ELGEMS

The letter bellow (12 pages) provides the required information you asked in your E-mail of 12/10/99. The answers are in bold letters just after your question.

Radiation Leakage from the Transmission Source Lead Shipping Container.

Part : P/N 1191700005 -- MG ATC Lead Shipping Container

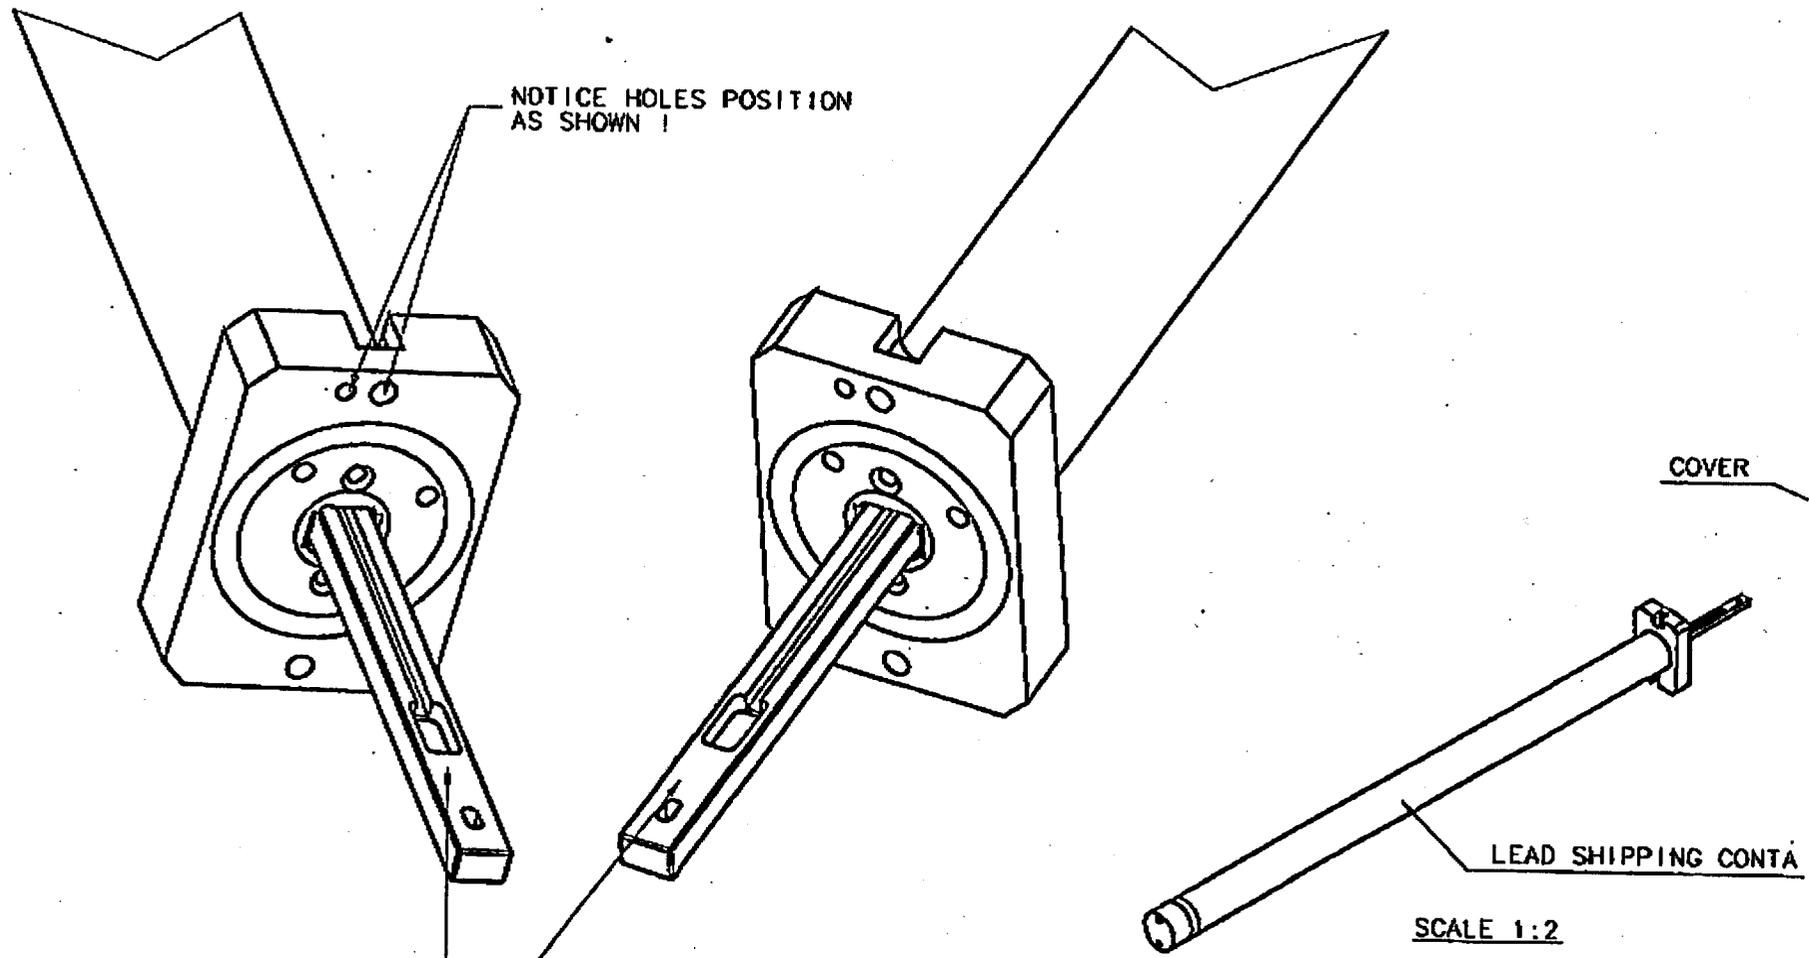
1. The SS&D registration certificate MA-0476-S-117-S dated 4/1/1999 stated that lead storage tube is no longer described in the certificate. Please clarify the following:
1. Who is responsible for manufacturing the lead shipping container having two line sources? Provide the QA/QC for the lead shipping container.

- All the parts of the lead shipping container are inspected according to the production engineering draws (see the original submission file, appendix H, page H-4 / H-17).
- After completion of the assembly, the unit is inspected before sending it to DuPont (see attached document pages 5,6,7 - Source Shipping Container - QC instructions D/N 410-3102-0303).

Test	Expected Result	Pass/Fail
Visually check the assembled part for any external damage	No external damage	
Check if any internal parts are loose and if any screws are not fully tightened.	No internal parts loose. Screws fully tightened.	
Disassembled the cover from the container and manually insert the source holder p/n 119040005 all the way in (see drawing MEC-005512).	Insertion/removing should be smooth with no internal obstacles or friction.
